AIR REPAIR, INC. 920 AIRPORT SERVICE ROAD CLEVELAND, MISSISSIPPI 38732 662.846.0228 - 662.843.0811 FAX sales@AirRepairinc.com	JACOBS ENGINE SERVICE BULLETIN	66
	MODE R755 A1 A2, A2M, B2, B2M	DATE 10/31/03
TITLE Improved Piston Oil Control Ring	PAGE 1 OF 1	BY PMJ
FAA APPROVAL Atlanta Aircraft Certification Office Letter 9-22-2004	ENGINEERING APPROVAL David L. Mayrose 8130-3 Dated August 30th, 2004

AIR REPAIR, INC. 920 AIRPORT SERVICE ROAD CLEVELAND, MISSISSIPPI 38732 662.846.0228 - 662.843.0811 FAX sales@AirRepairinc.com	JACOBS ENGINE SERVICE BULLETIN	67
	MODEL R755 A1,A2,A2M, B2, B2M	DATE 10/31/03
TITLE Improved Pistons in Cylinders #4 and #5	PAGE 1 OF 1	BY PMJ
FAA APPROVAL Atlanta Aircraft Certification Office Letter 9-22-2004	ENGINEERING APPROVAL David L. Mayrose 8130-3 Dated August 30th, 2004	
<p>Install part number 4290 pistons in cylinders number 4 and 5 only to alleviate oil drain back problems into the lower cylinders.</p> <p>Install these pistons in pairs using the standard ring configuration and fits as called out for the 4276 Rev C pistons in Service Bulletin 54C.</p> <p>These pistons are also eligible for use with the improved 4292 oil control rings as called out in Ser

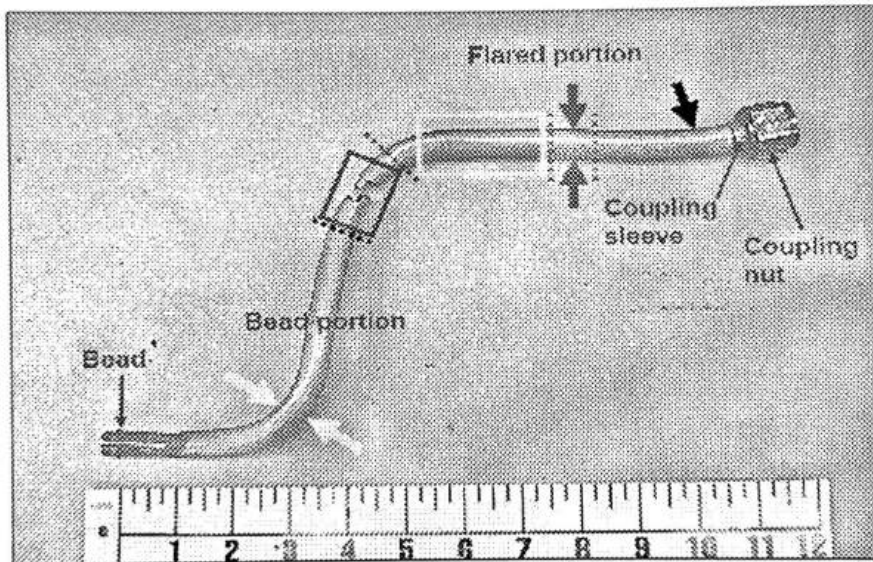
Service experience with the legacy Jacobs R-755 series radial engines has indicated high time copper vent and scavenge oil drain tubes identified above as Jacobs P/N may be subject to metal fatigue and subsequent fracture of the copper drain tube as illustrated in Figure 1 with resulting oil leakage. One documented fatigue failure indicated the part was at least 34 years old. Work hardening can occur during field fabrication unless the tubes are annealed after fabrication; there is no FAA repair guidance for annealing copper tubing.

Within the next 25 hours of operation, inspect the copper oil drain lines listed above for signs of oil leakage, cracks, or other damage and replace as necessary with new FAA approved replacement parts available from the Type Certificate Holder. Specifically inspect each line for signs of chaffing, deformation of crosssection, or other unacceptable condition. Physical inspection should pay close attention to tubing bend areas and the beaded end of the tube, reference Figure 1.

Thereafter inspect annually or every 100 hours, whichever occurs first until factory new Air Repair replacement parts are installed. Field fabricated replacement tubes should be replaced with factory new FAA approved replacement parts. Replace any drain line for which the time in service cannot be verified. Note that overhaul intervals vary among engine models. For the purpose of this service bulletin, the life of FAA approved replacement parts shall be same as the overhaul interval for the specific engine model but shall not exceed 1400 hours under any circumstances. Drain lines should not be repaired.

FAA approved Air Repair replacement parts are identified above and may be obtained by contacting the Type Certificate Holder at the above address. Inspect attaching hose sections and replace if hardened or cracked. Coat mating fitting threads with anti-seize compound. Note there may be other configurations of the above oil lines depending upon aircraft installation.
